Access Compliance Report Public Rights-of-Way (Curb Ramps)

Main Street: KOOTENAY_DR Cross Street: SANTA_CLARA_AVE Location: NE

ADA ID: RPAT211026094455 Ramp Type: Type 1 - Perpendicular Diagonal Initial Pass/Fail: Pass Overall Compliance: No Severity Score: 0

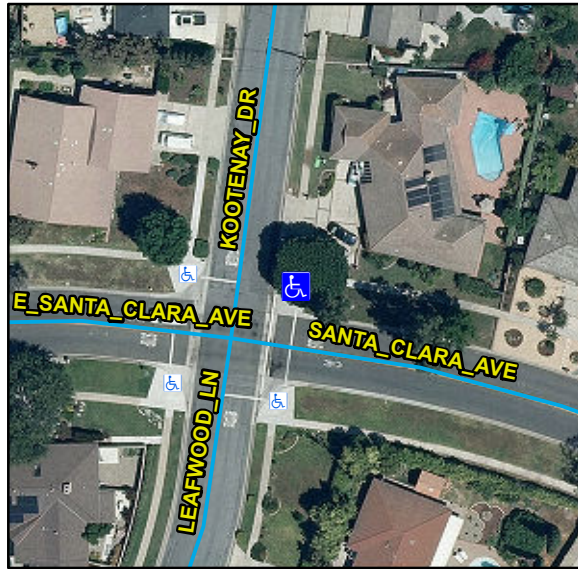
R304.2.2, R304.2.2-Perp, R304.3.2-Para, STD 1115

Remove & Replace Curb Ramp With Two New Directional Ramps or Equivalent.
